**ROAD EVALUATION REPORT**  
for  
**BROWN ROAD**  
**EL PASO COUNTY, COLORADO**  
for the  
**PRAIRIE RIDGE SUBDIVISION**

**August 14, 2020**

**PCD File No. SF2010**

County DPW staff will be assessing the conditions of Brown Rd to confirm what has been provided in this report. We will forward any information provided once the assessment has been completed.

## Exhibit 6: Brown Road Cross Sections

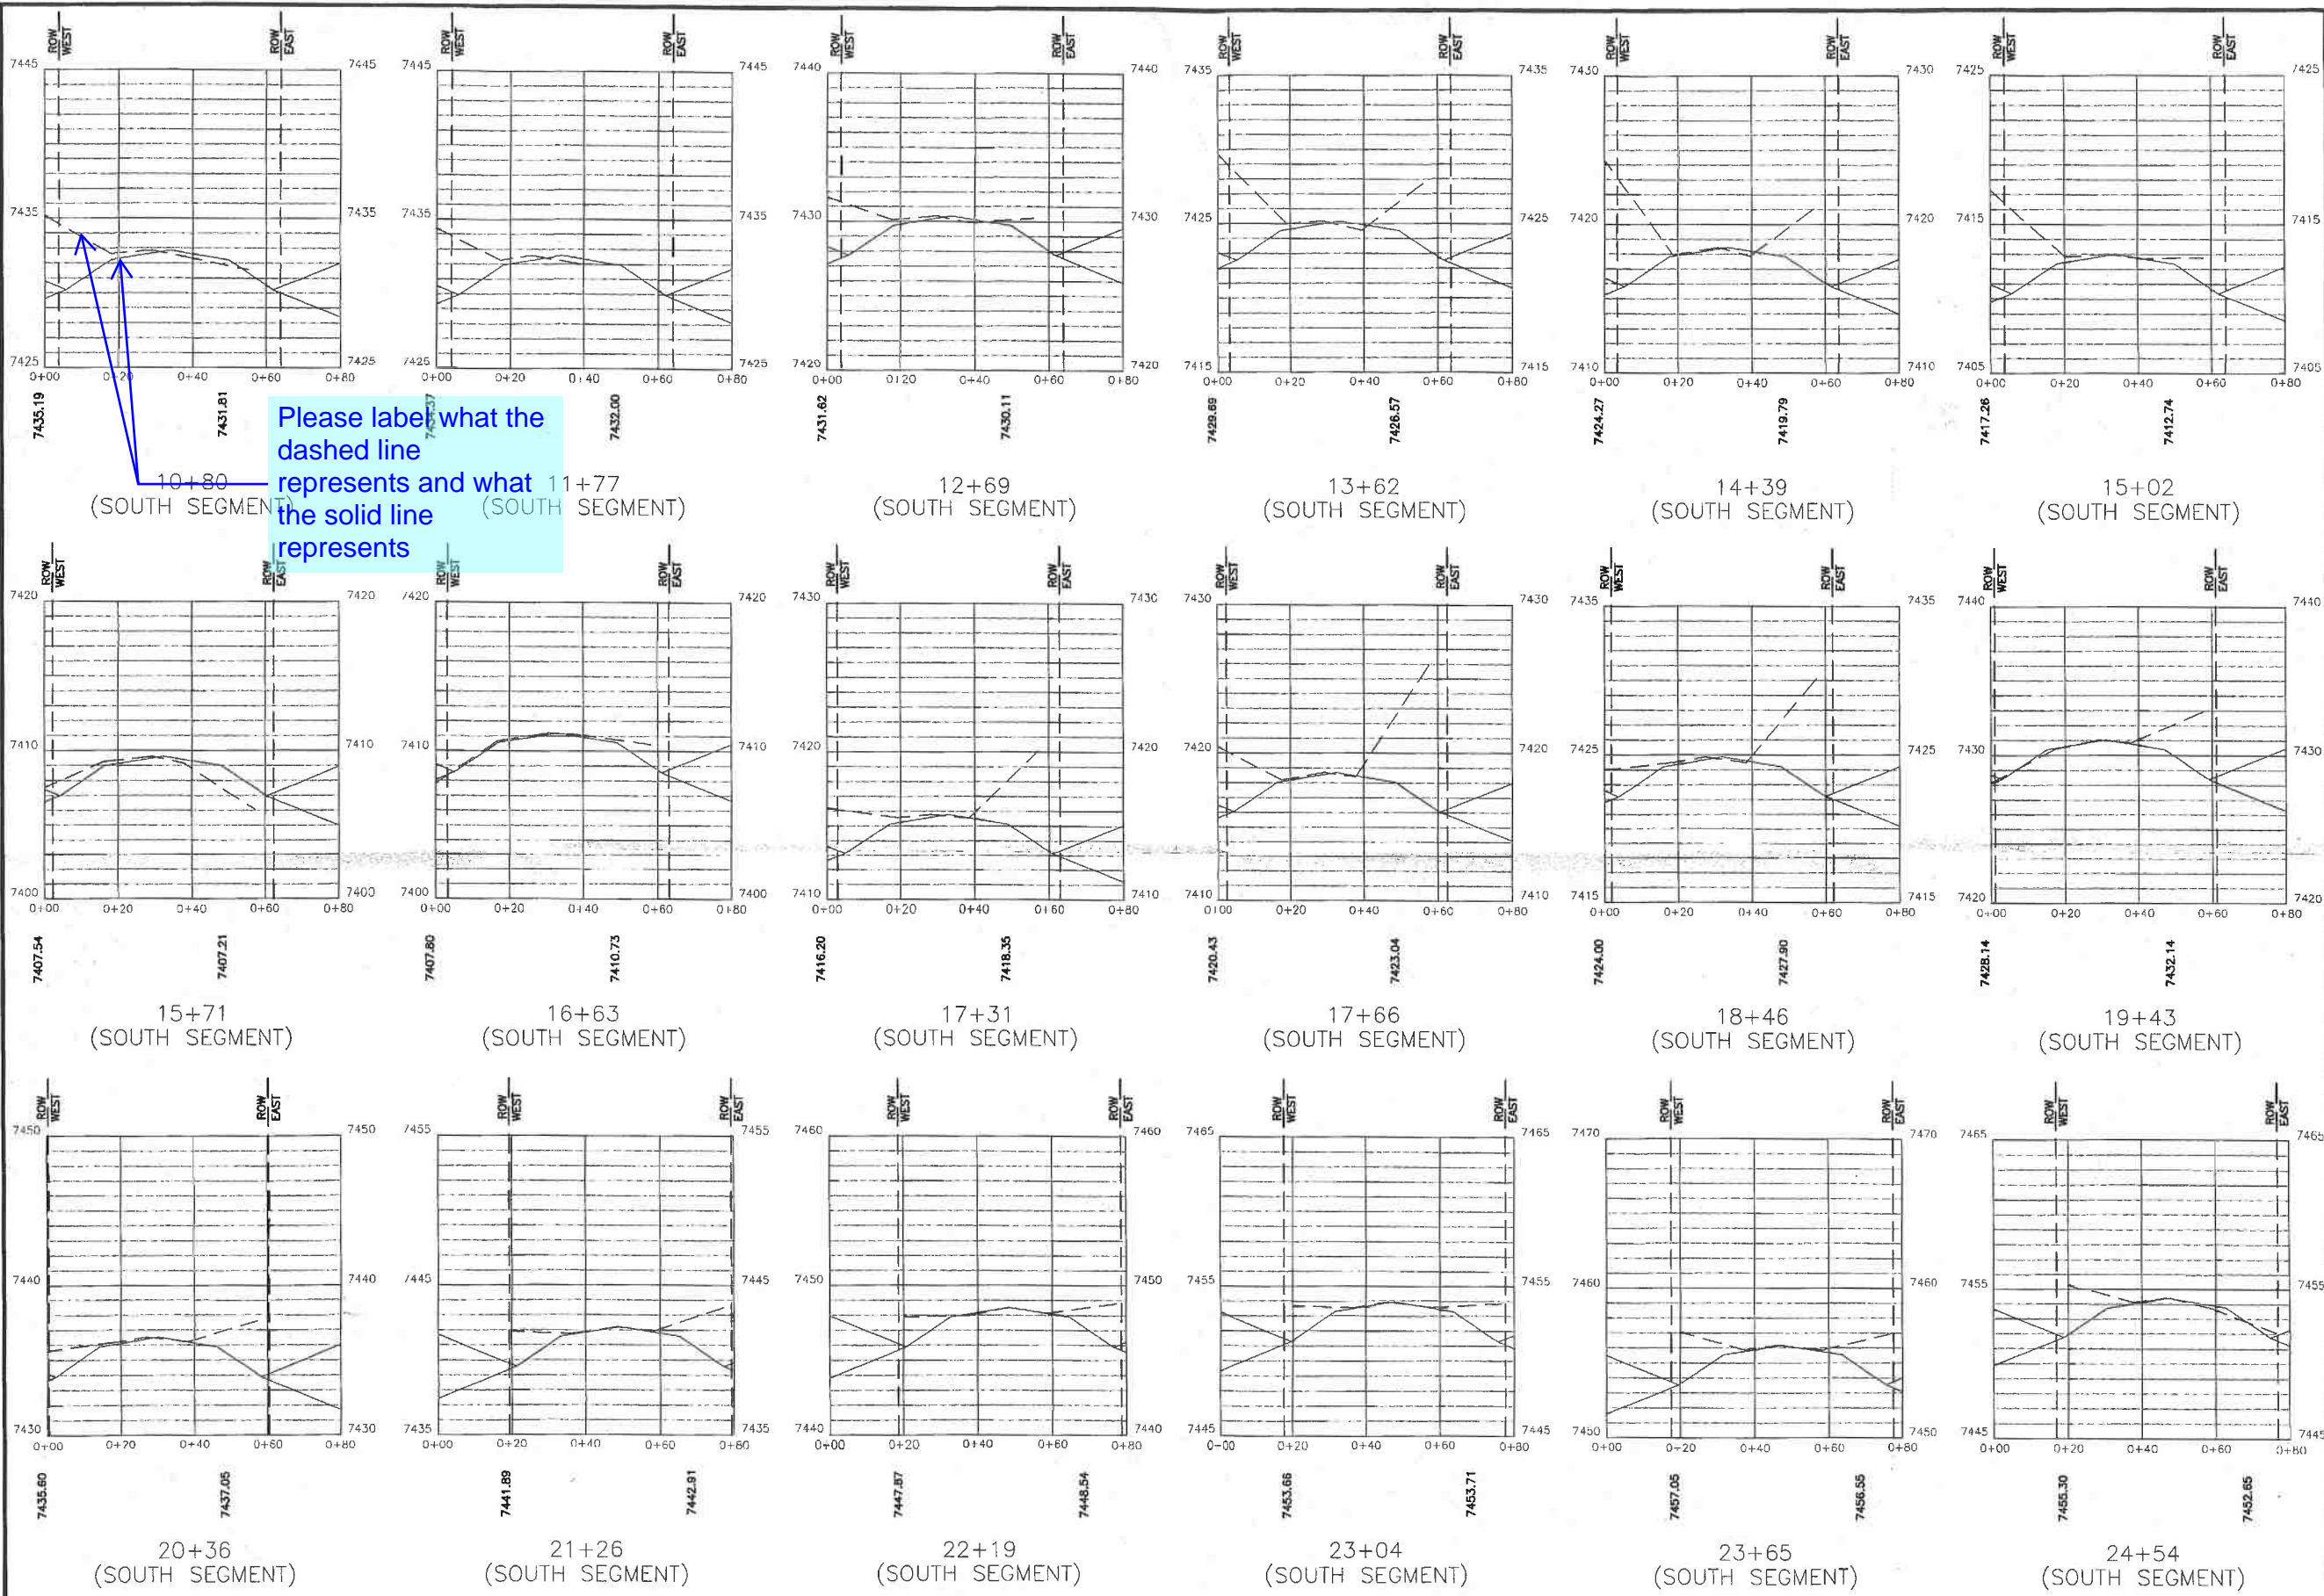
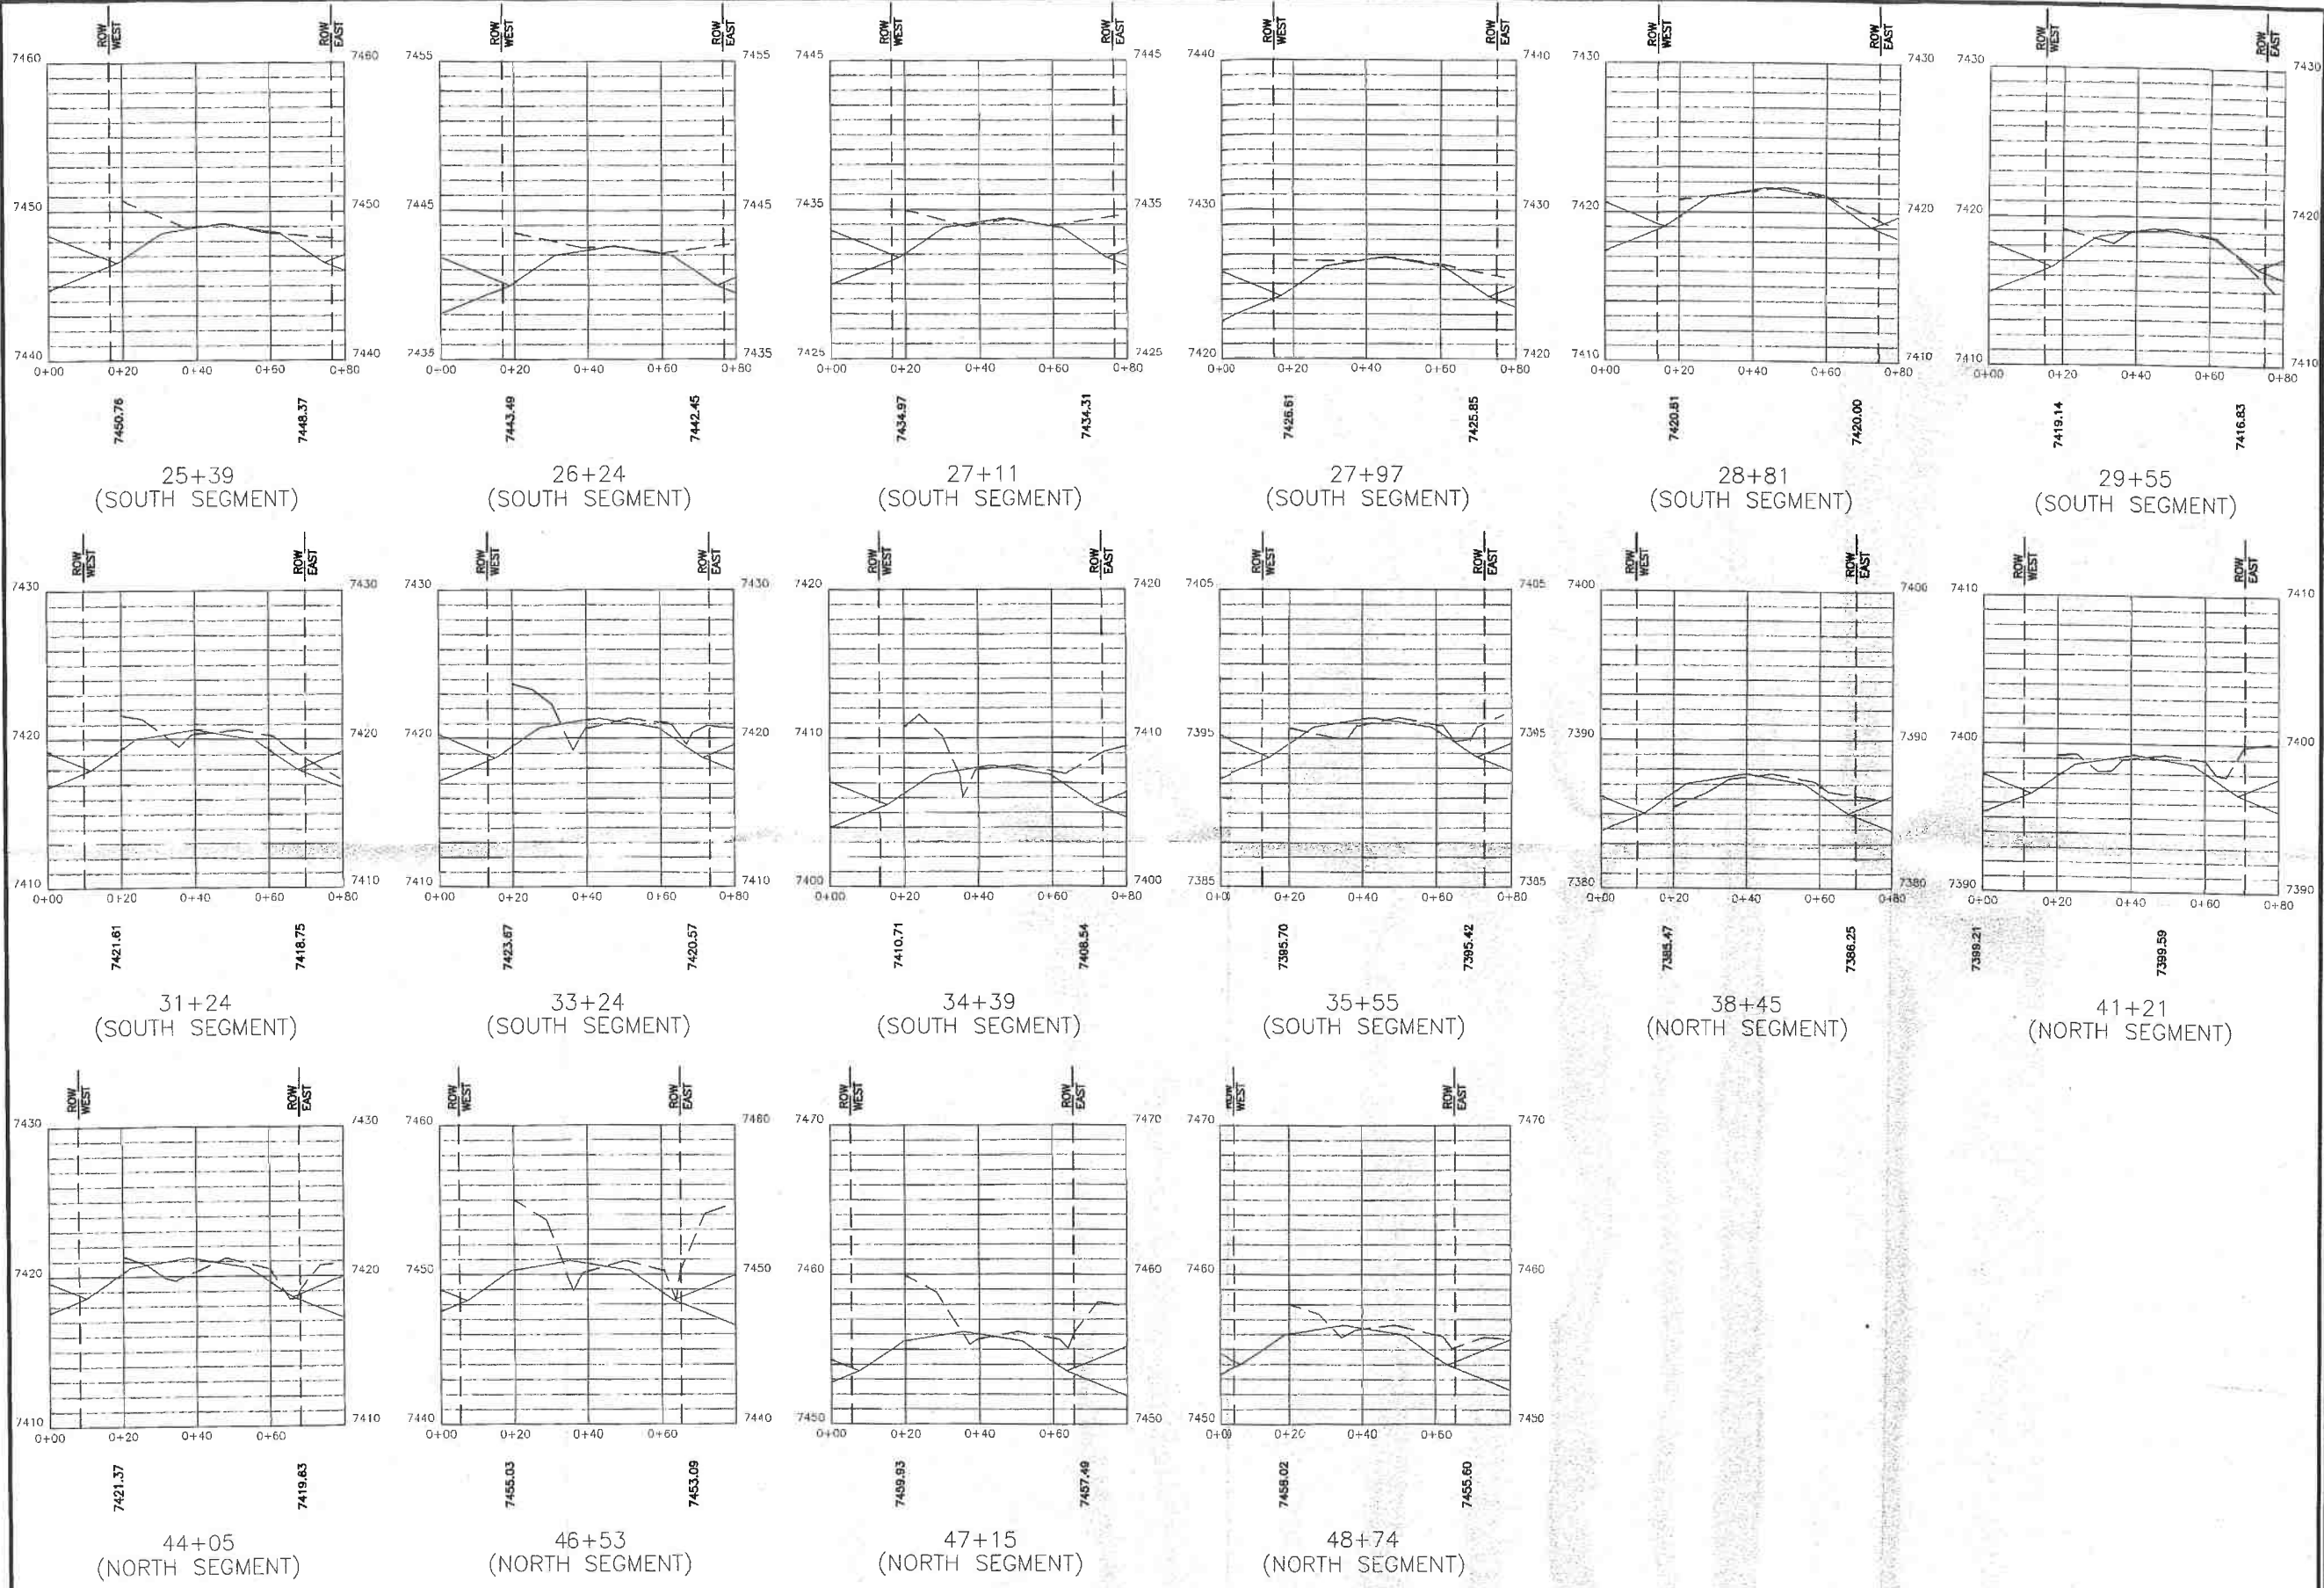
Please label what the dashed line represents and what the solid line represents
